Maxtor Corporation
500 McCarthy Boulevard
Milpitas, CA 95035 USA

To: T10 CAP Working Group
Contact: Mark Evans
Phone: 408-894-5310
Email: mark_evans@maxtor.com
Date: 18 April 2003

Subject: SAM-3, SPC-3, and SBC-2 power conditions proposal

Figure a — Power condition state machine

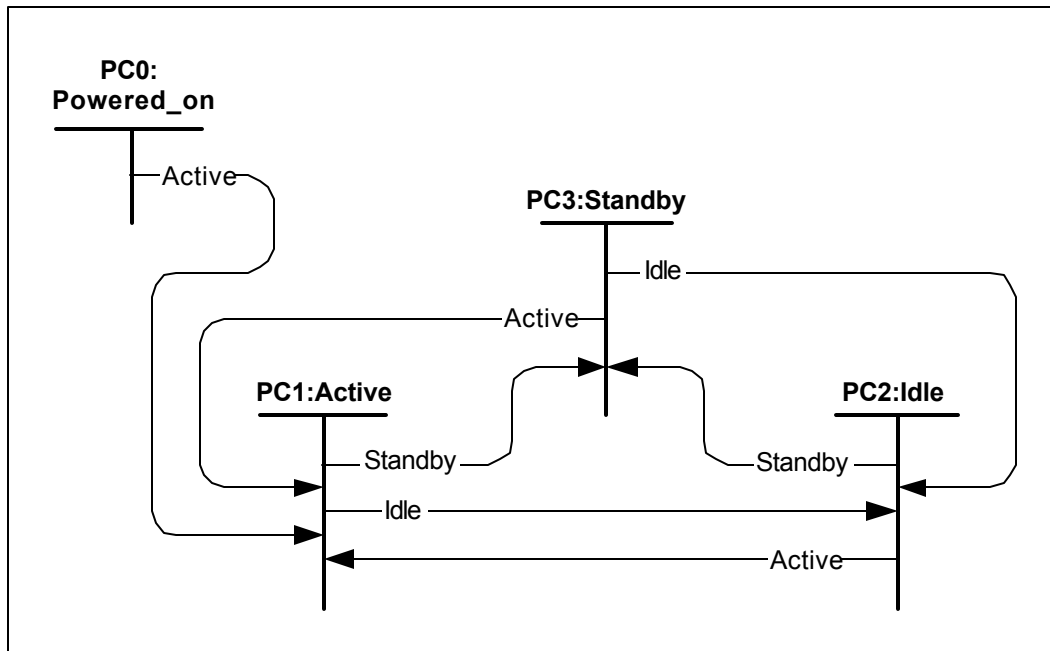
In SPC-3: Replace subclause 5.8 with the following:

- a) PC0:Powered_on (see 5.8.2.2) (initial state);
- b) PC1:Active (see 5.8.2.3);
- c) PC2:Idle (see 5.8.2.4); and
- d) PC3:Standby (see 5.8.2.5).

The PC state machine shall start in the PC0:Powered_on state after power on.

Figure a describes the PC state machine.

Figure b — Power condition state machine for logical units implementing the START STOP UNIT command

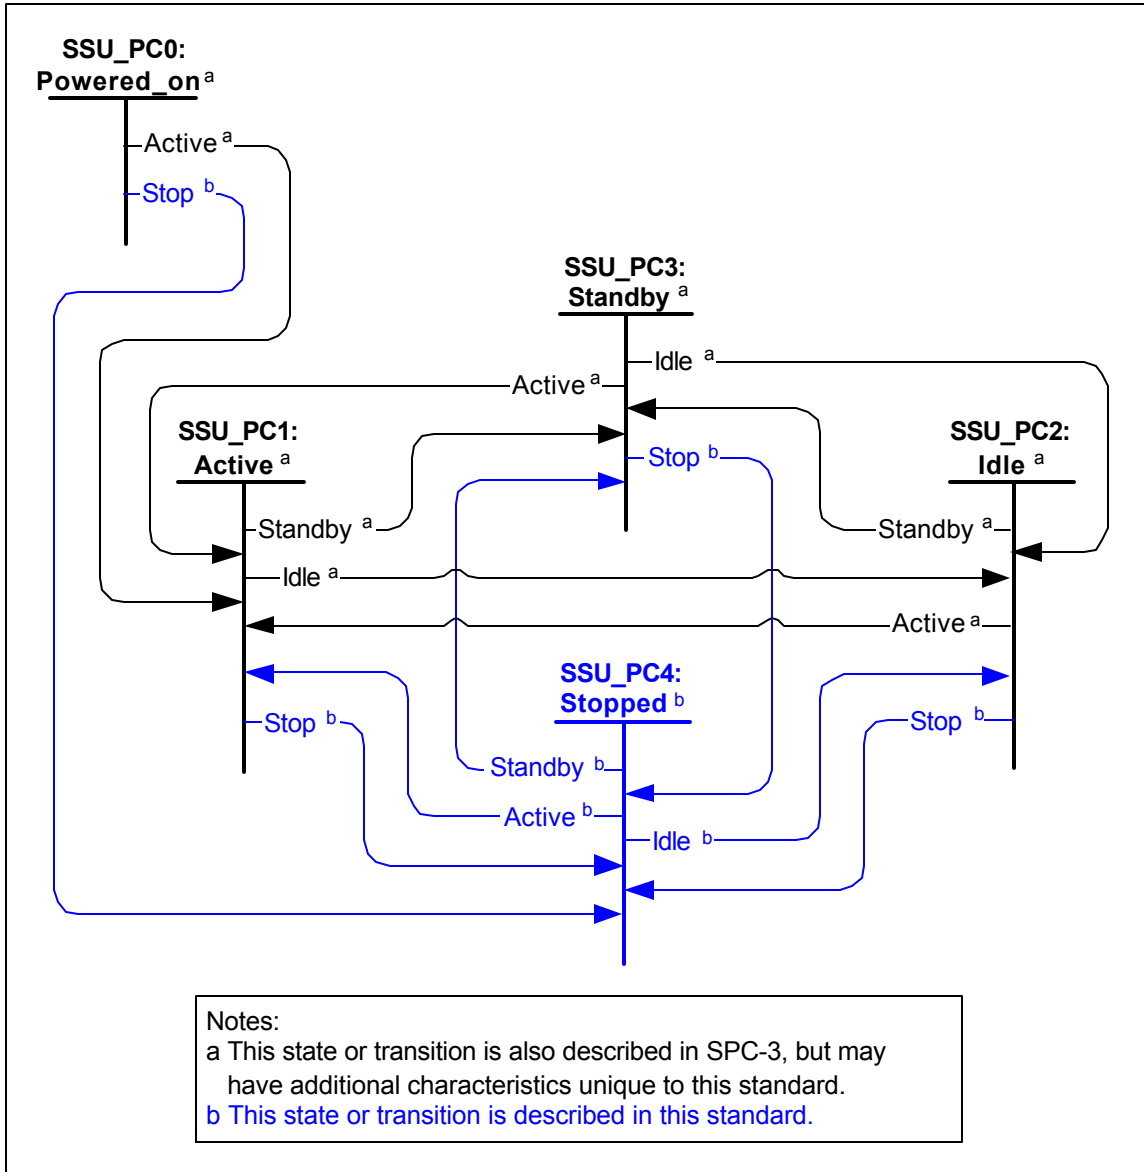
In **SBC-2**: Add the following in the Models clause.

- a) SSU_PC0:Powered_on (see 4.2.1.0.2.2) (initial state);
- b) SSU_PC1:Active (see 4.2.1.0.2.3);
- c) SSU_PC2:Idle(see 4.2.1.0.2.4);
- d) SSU_PC3:Standby (see 4.2.1.0.2.5); and
- e) SSU_PC4:Stopped (see 4.2.1.0.2.6).

The SSU_PC state machine shall start in the SSU_PC0:Powered_on state after power on.

Figure b describes the SSU_PC state machine.
